**WB/NB SEGMENT LAS VEGAS BELTWAY EL CAPITAN TO JONES RAMP "ES" OVER RAMP "R2" & "R3" BARRIER RAIL DETAILS**  
 CLARK COUNTY, NEVADA, DEPARTMENT OF PUBLIC WORKS

WB/NB SEGMENT LAS VEGAS BELTWAY EL CAPITAN TO JONES  
RAMP "ES" OVER RAMPS "R2" & "R3"  
STRIP SEAL EXPANSION JOINT DETAILS  
CLARK COUNTY, NEVADA, DEPARTMENT OF PUBLIC WORKS

**WB/NB SEGMENT LAS VEGAS BELTWAY-EL CAPITAN TO JONES**  
**UTILITY PLAN**  
**"A" LINE STA. 950+00 TO STA. 980+00**  
**CLARK COUNTY, NEVADA, DEPARTMENT OF PUBLIC WORKS**

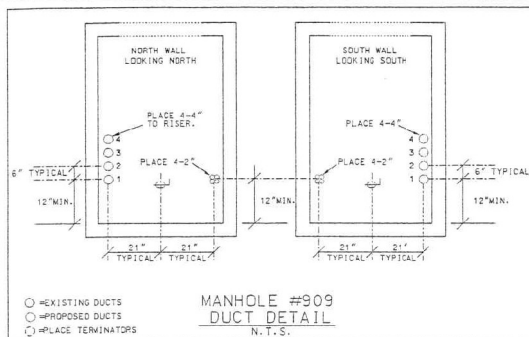
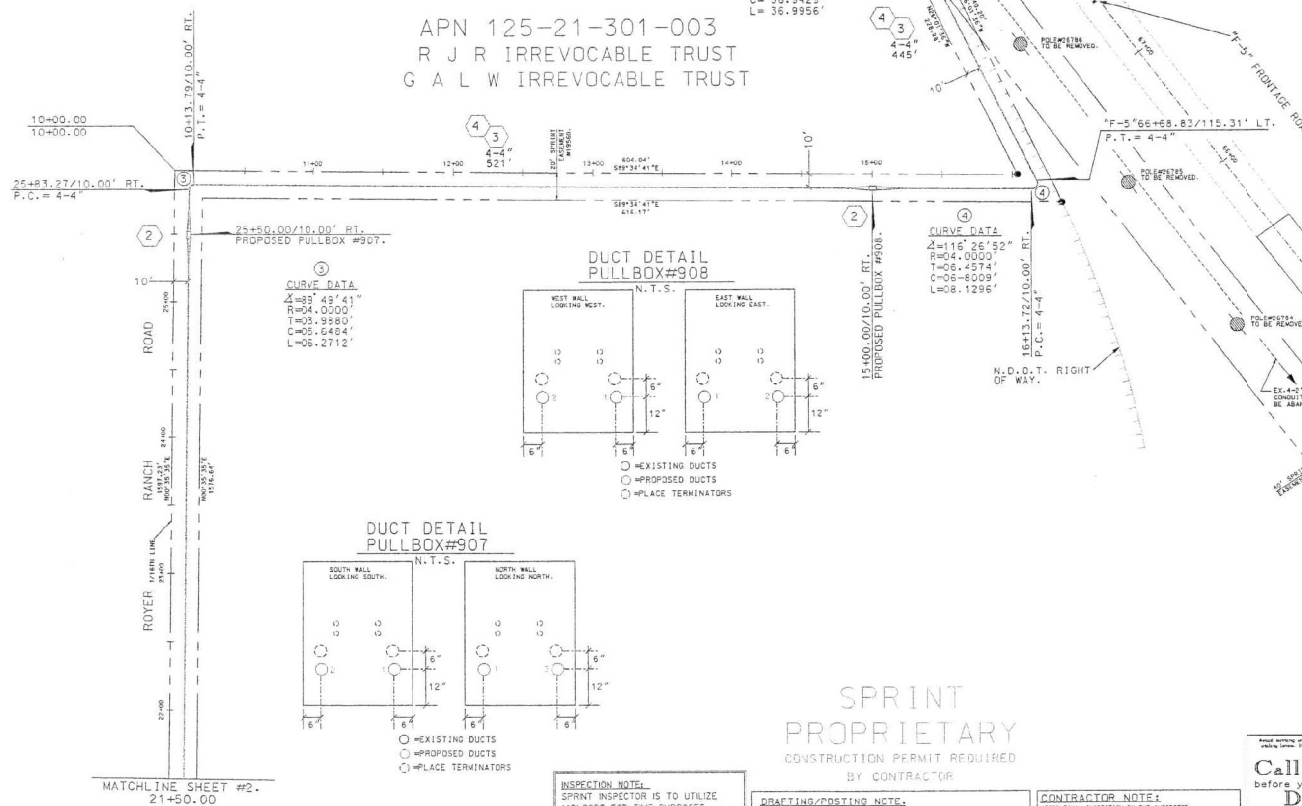
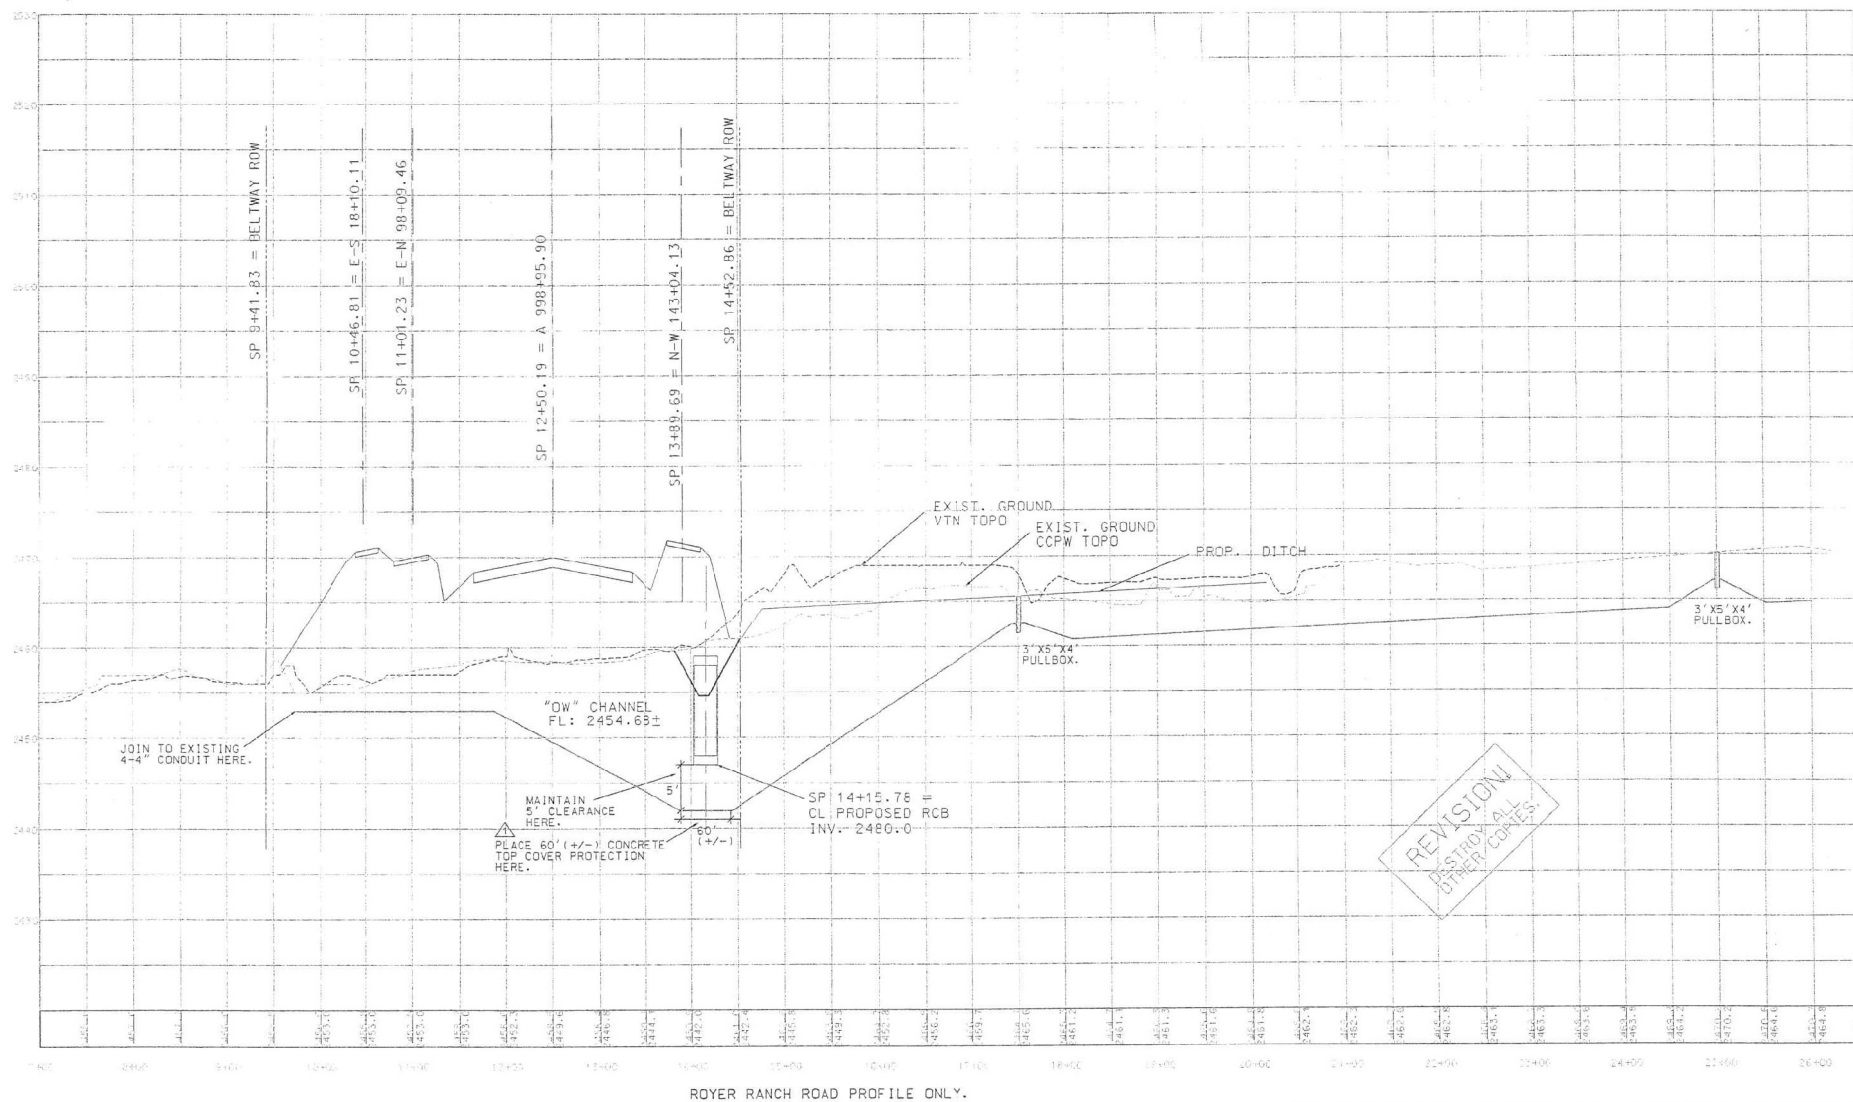
|                                                                                         | NO. 1<br>CORRECTION IN DIMENSION FOR COVER PROTECTION BENEATH<br>PROPOSED S.F.B. SHEET 4 OF 4. |                  | DATE<br>11/10/00 |

| NO. | REVISION                                                                              | BY           | DATE     |
|-----|---------------------------------------------------------------------------------------|--------------|----------|
| 1   | CONNECTION IN DIMENSION FOR COVER PROTECTION BENEATH<br>PROPOSED R.S.B. SHEET 4 OF 4. | DAVID MORENO | 11/10/00 |
